REMARKS

Claims 20-28 are rejected under 35 U.S.C. 103(a) as being unpatentable over the applicant's prior art figure (APAF) is view of Yamazaki et al. (US 6,677,613 B1). Response to the Office Action identified above is listed below.

Fig. 7 Prior art

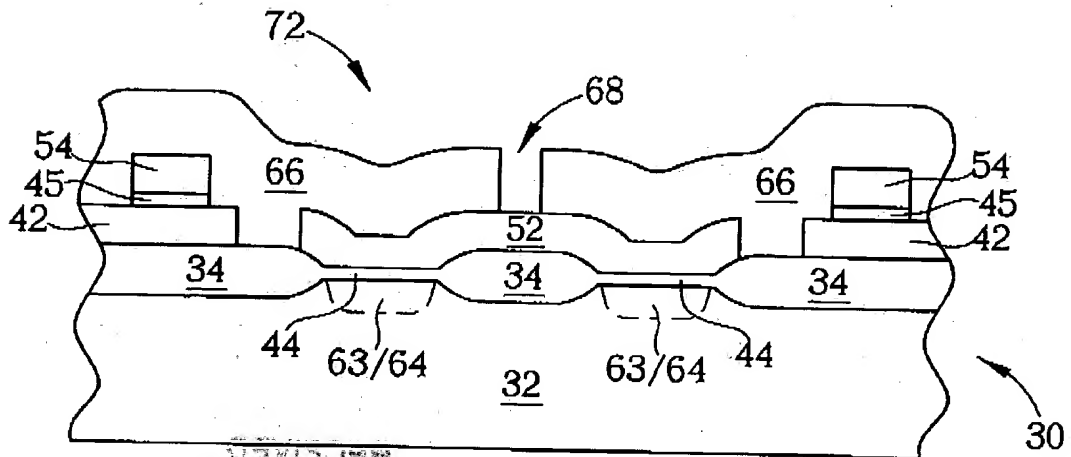
In re claim 20, the APAF 7 shows a microdisplay pixel cell device comprising a semiconductor substrate defined with a plurality of active areas at least one gate (52), the gate covering a portion of the active area, at least one source/drains (63/64), the source/drain being in the active area, and a first dielectric layer (66) the first dielectric layer covering the gate and the source/drain. The first dielectric layer comprises at least one row select contact plug (68) to electrically connect to the gate and at least one row select line, the row select line being atop the first dielectric layer, the row select line being electrically connected to the gate through the row select contact plug. There is at least one pixel cap top plate (42) on the first dielectric layer, at least one capacitor dielectric layer (45), the capacitor dielectric layer being atop the surface of the top plate; and at least one pixel cap bottom plate (54). The

APAF 7 shows all of the elements of the claims except the second dielectric layer being atop the first dielectric layer. Yamazaki et al. shows (figs. 1A-3) a pixel cell device comprising a first dielectric layer (125) formed over a gate (109), and a second dielectric layer (134) formed on the first dielectric layer. Yamazaki also shows a pixel cap bottom plate (139) being atop the second dielectric layer and covering a capacitor top plate (135) and a capacitor dielectric layer (135). With the capacitor being formed simultaneously being formed with the light shielding layer, the area of the pixel electrode could be reduced and a sufficient capacitance could be provided (col.9, lines 29-35).

In re claim 21, the APAF 7 shows that the gate comprises a gate oxide layer (44), a polysilicon layer or a metal silicide layer.

Fig. 8

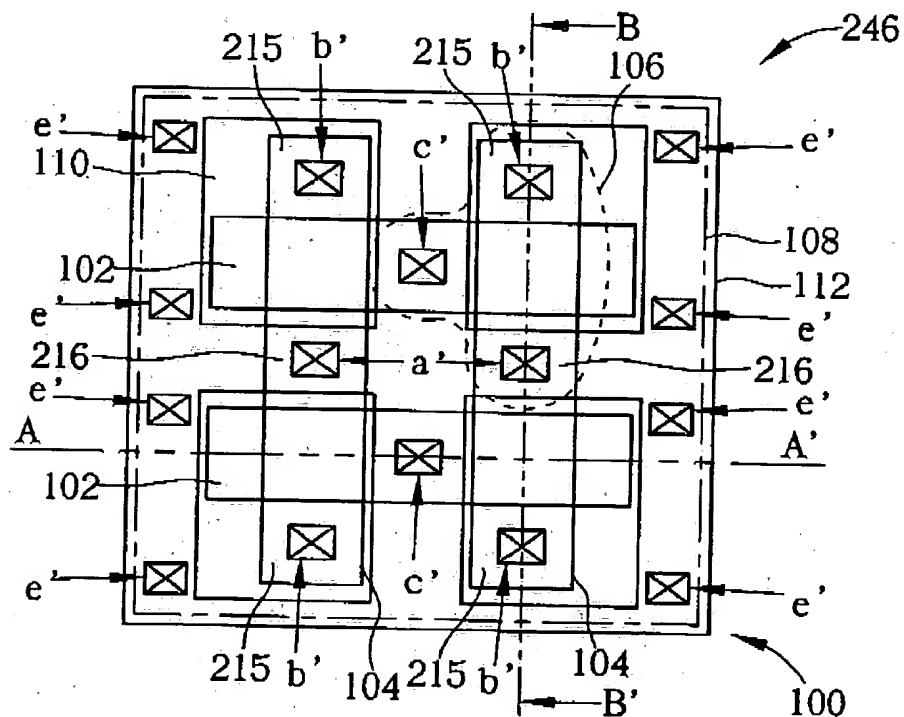
Claim 20 is amended in the above AMENDMENTS TO THE CLAIMS section. Fig.8 is amended and Fig.15 is added in the above AMENDMENTS TO THE DRAWINGS section and paragraphs [0023], [0026], [0029] are amended in the AMENDMENTS TO THE SPECIFICATION section. In Fig.11, the gate layer (214) is above the source/drain regions (215/216) because this cross-sectional diagram is drawn along A-A' in Fig.8. Actually, either of the source region 215 and the drain region 216 is in the

5 The attached sheets of drawing include changes to
Fig. 8 and a new added sheet of Fig.15. The sheet, which
includes Fig. 7-8, replaces the original sheet
including Fig. 7-8. In Figure 8, a cross-sectional line
B-B' previously omitted has been added and the arrows
for indicating two source contact plugs b' are shifted.
10 Fig.15, which is a cross-sectional diagram along line
B-B' in Fig.8, has been added in order to illustrate
the sites for sources, drains, and gates, which has
already been shown in Fig.8, more clearly.

Fig. 15

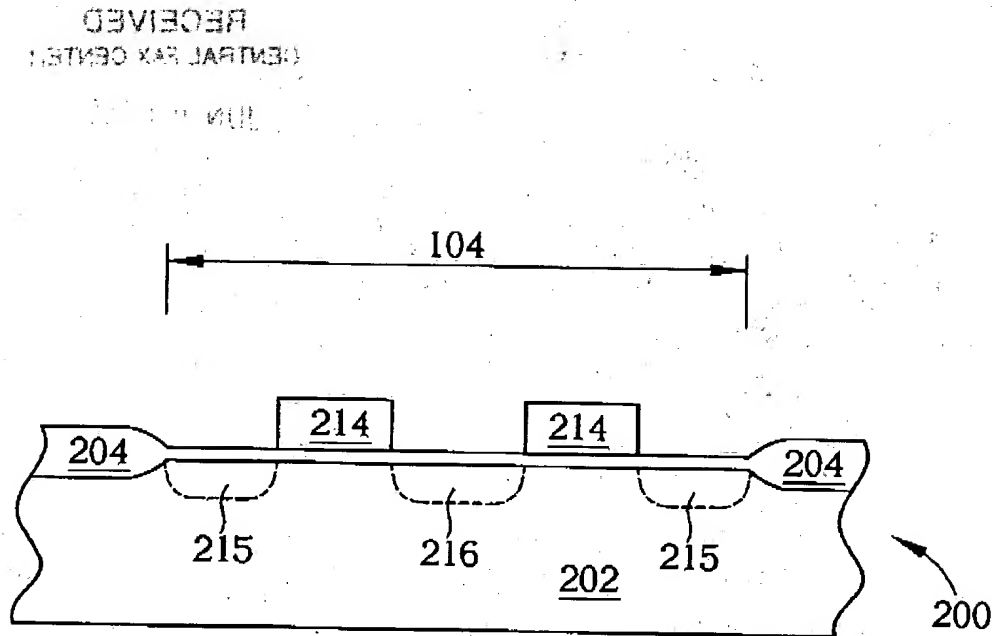
Fig. 15 is drawn along line B-B' in Fig. 8 such that at least one complete transistor 106 is shown in a cross section so as to illustrate the relative sites for sources 215, drains 216, and gates 214 more clearly. In Fig. 15, it is very obviously that the source 215 and the drain 216 are in the active area 104 not covered by the gate 214. No new matter is added.
